**THE CITY OF THE VILLAGE OF DOUGLAS
PLANNING COMMISSION
THURSDAY, AUGUST 14, 2025 AT 6:00 PM
86 W CENTER ST., DOUGLAS MI**

AGENDA

Re: 312 Ferry Street – Consumers Credit Union – Site Plan Review #1 for Bosch Architecture PN: 25007
Sheets C001, C002, C003, C004, C501, for submittals dated 2025-05-08

Bosch Architecture Engineering & Interior Design has submitted a set of site plan review plans, dated May 8, 2025, for the proposed Consumers Credit Union building located at 312 Ferry St. Douglas, Michigan, 49406. The purpose of this memorandum is to review the sanitary sewer, and water distribution system in accordance with the Kalamazoo Lake Sewer and Water Authority (KLSWA) Construction Standards, Ten State Standards for water and sewer, and the Michigan Plumbing code.

Cool
CONCEPTUAL SITE PLAN

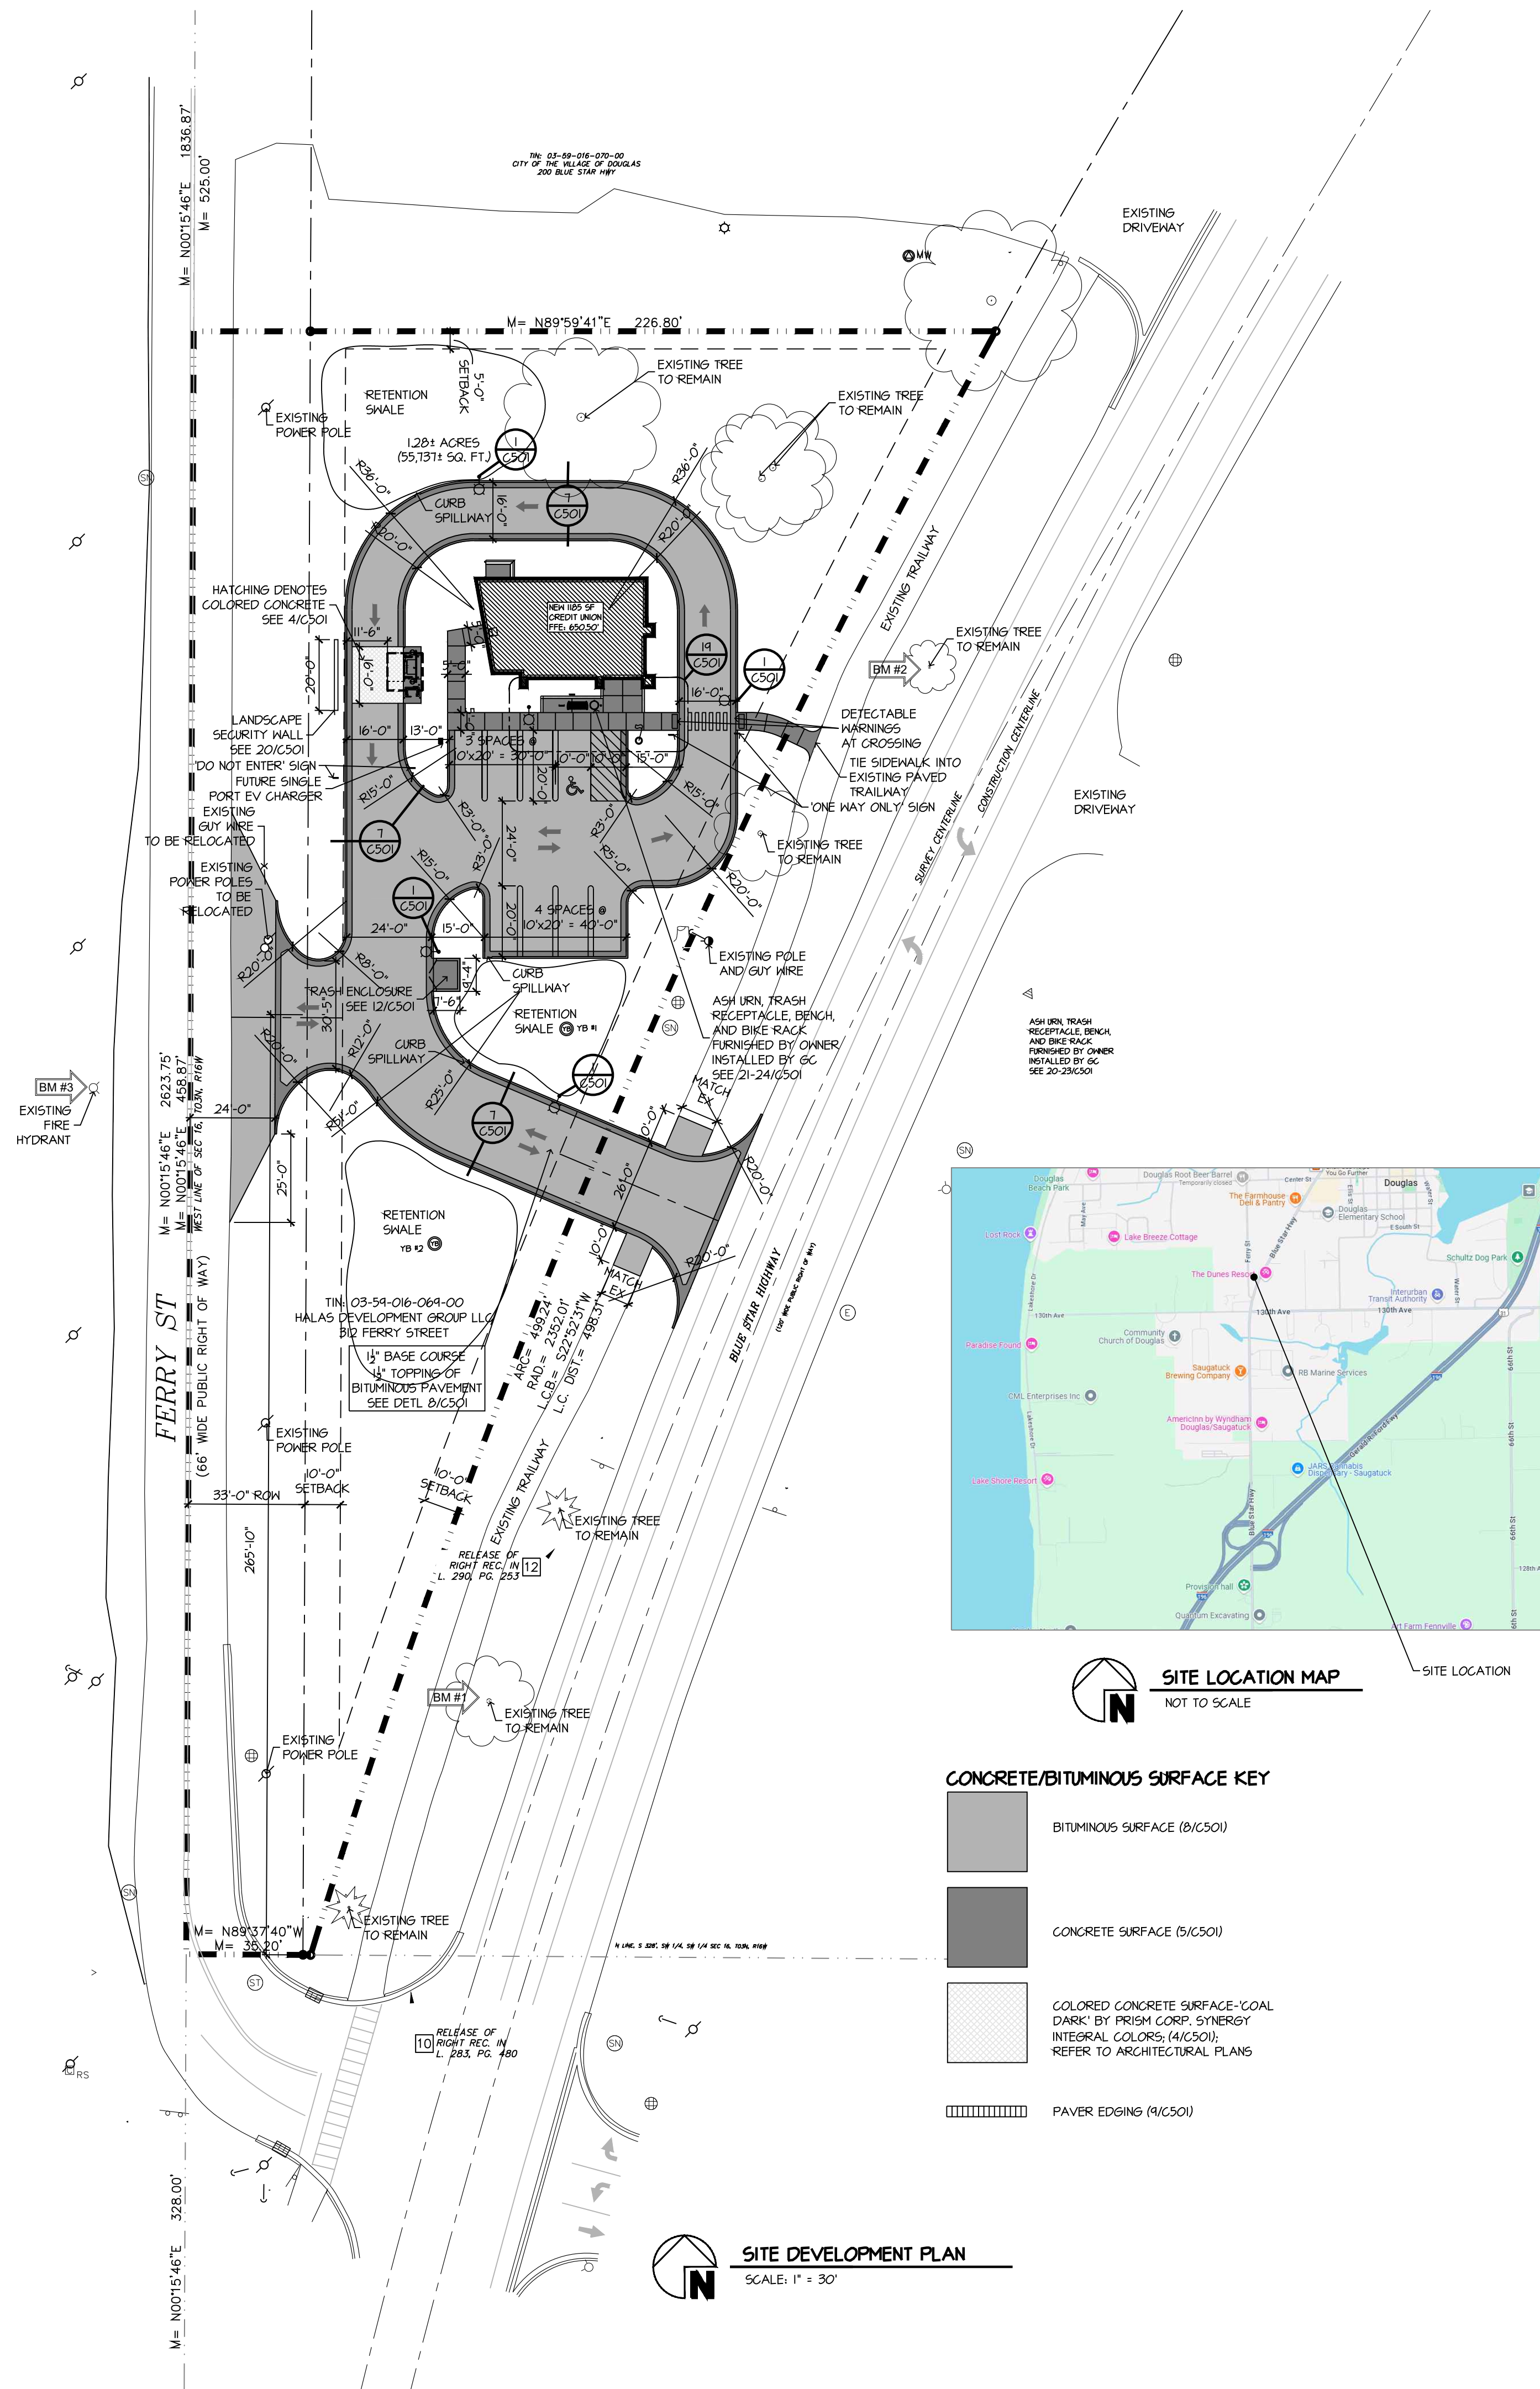
1. Vehicle impact protection required by this code shall be provided by posts that comply with Section 312.2 or by other approved physical barriers that comply with Section 312.3. (312.1) ***Bollard posts are required to protect the gas meter and are not shown in the plans provided. Please include in gas meter location and protection in revised submittals (If applicable).***

3. "No Parking Fire Lane" signage shall be installed at the dead end of the turnaround. (IFC 503.3) ***Please see locations of "No Parking Fire Lane" signage indicated on markup plans.***

6. Minimum clear height shall be 13'6" across the entire 20ft width of driveway. (IFC 503.2.1) ***Height clearance is not noted in plans provided. Please include in revised submittals indicating the drive-thru will have a minimum vertical clearance of 13'6".***

7. Road shall not exceed the 10% maximum grade. (IFC 503.2.7) ***Grade does not appear to be shown in the plans provided, please include in revised submittals.***

8. The driveway shall be installed with asphalt, concrete, or other approved driving surfaces capable of supporting the 80,000-pound imposed load of our heaviest apparatus and be installed to provide emergency access prior to commencement of building construction. (IFC 503.2.3) ***Weight capacity is not noted in plans provided. Please include in revised submittals to support 80,000lbs.***

**SITE PHOTOMETRIC PLAN**
SCALE: 1" = 30'

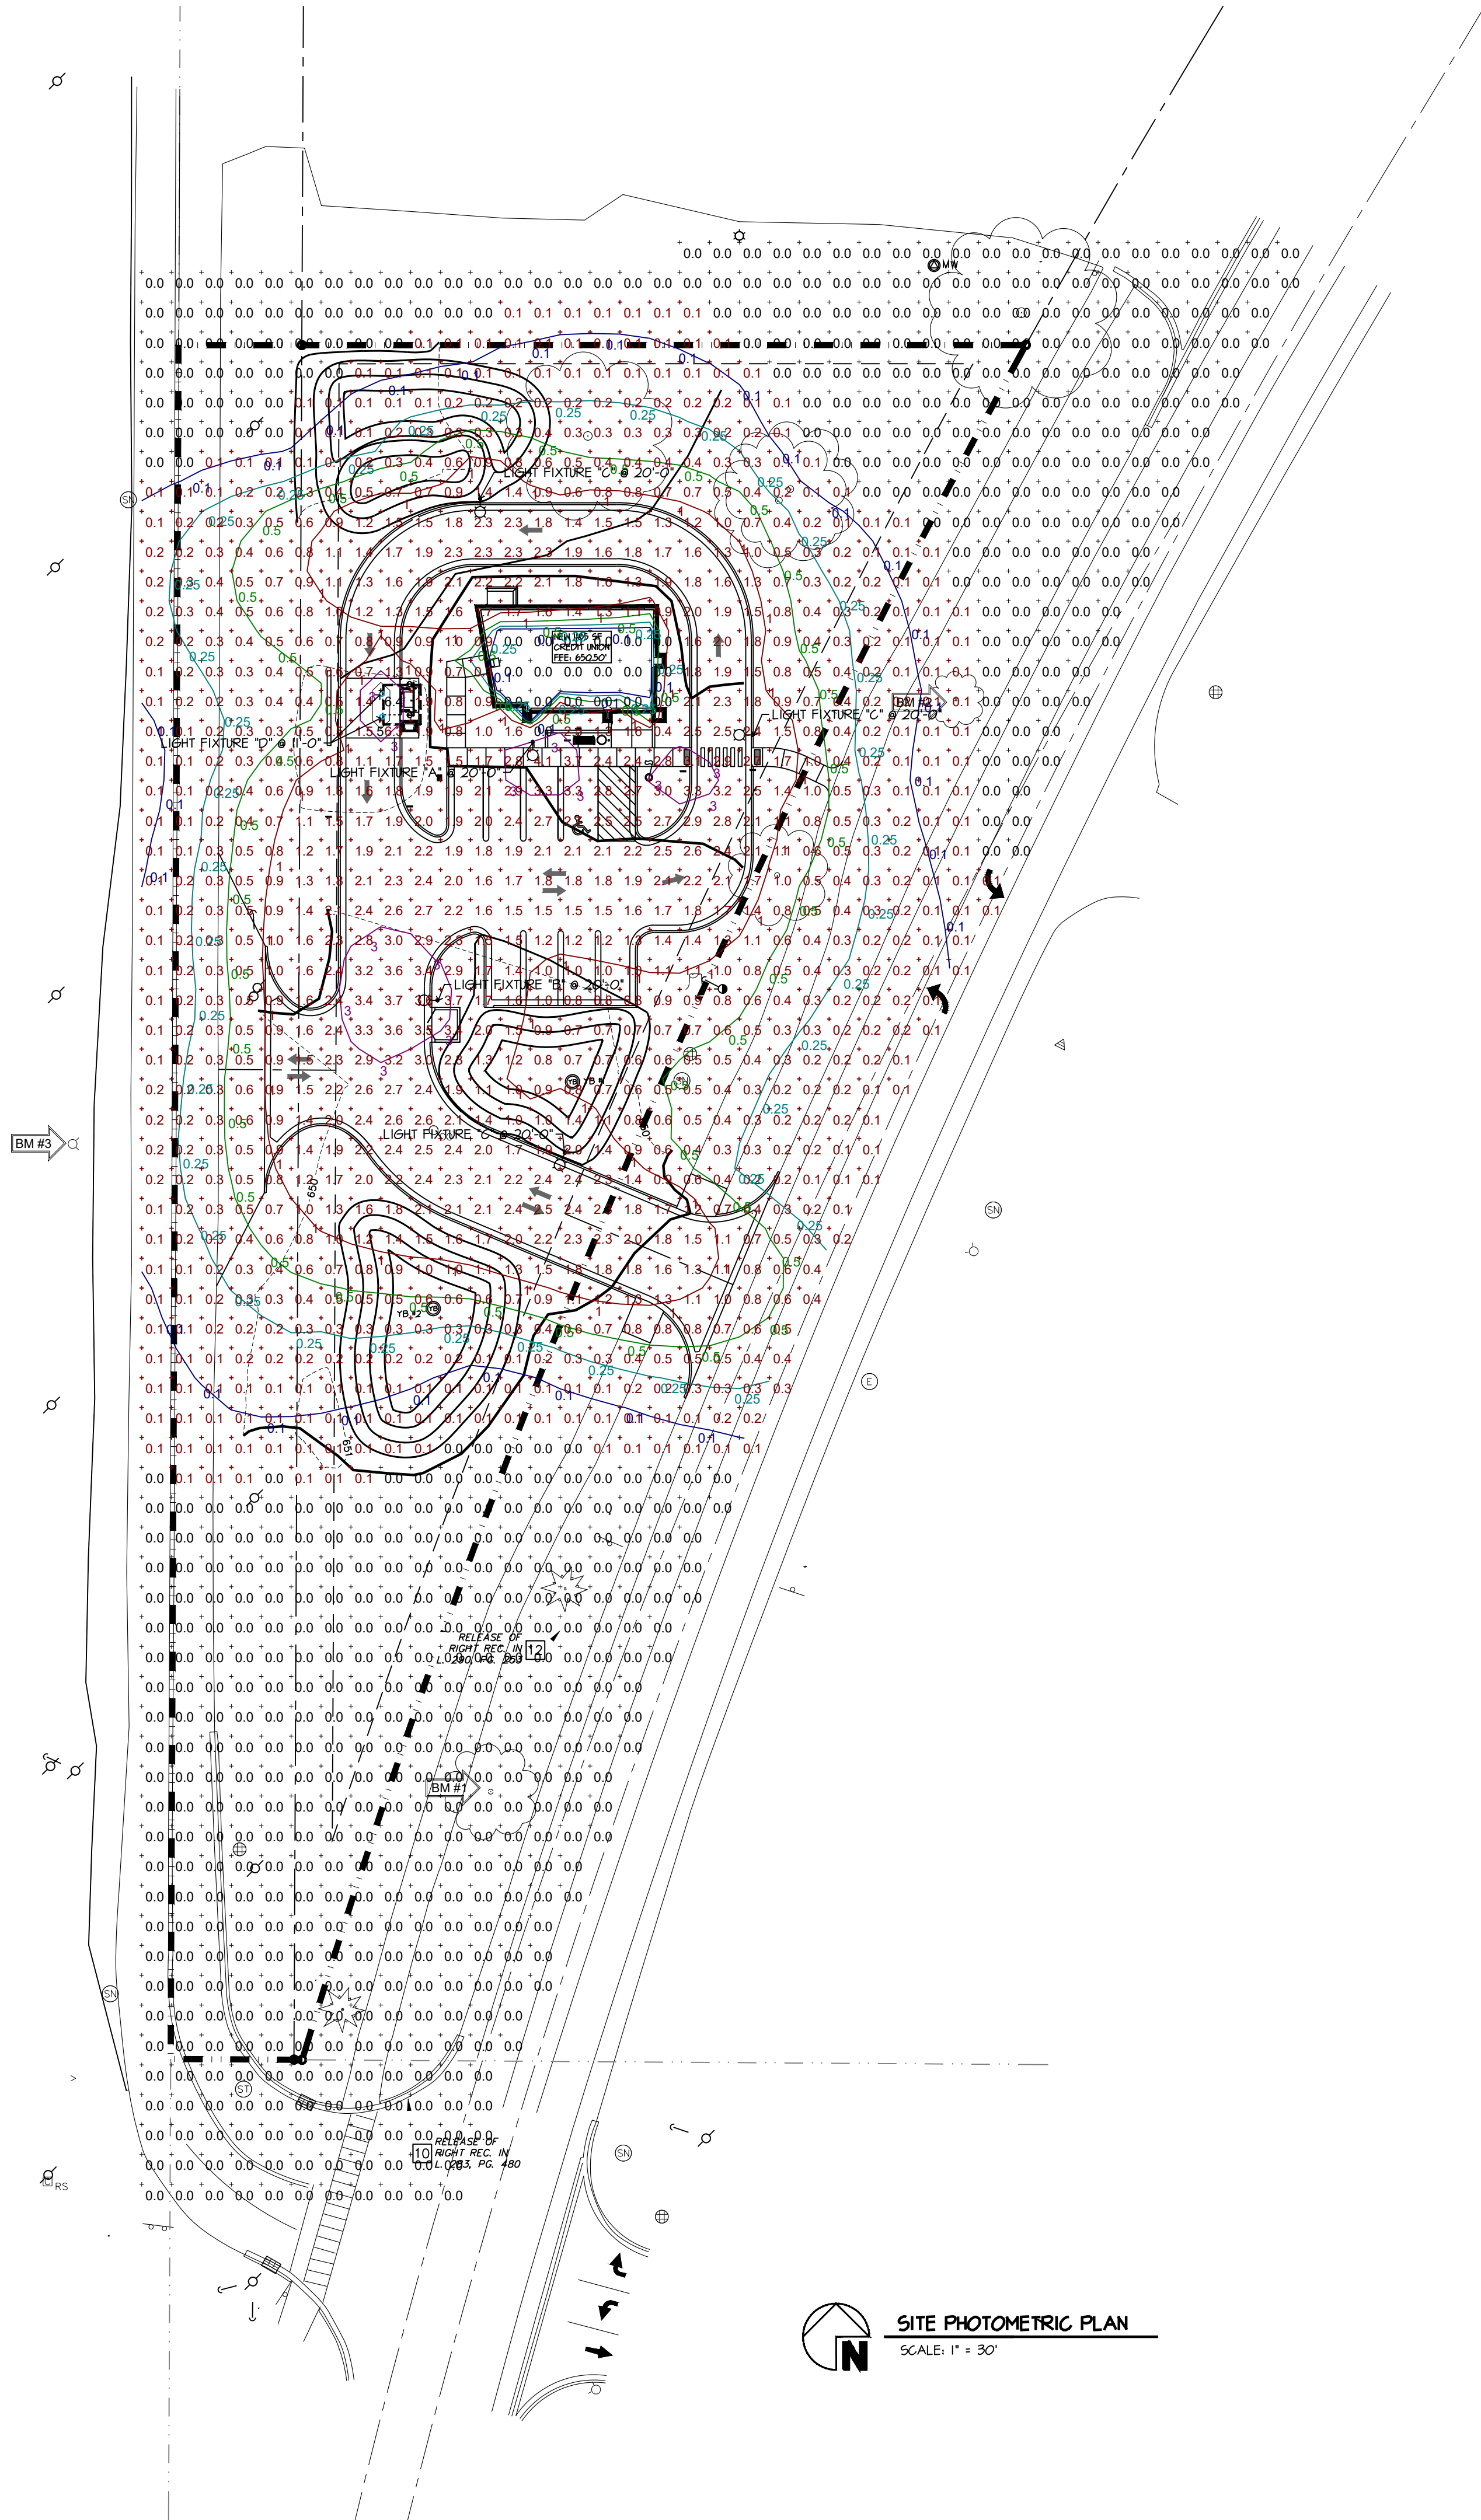
Remarks. A site photometric plan was provided and appears to comply with Section 19.05(6) and Section 24.03(9)
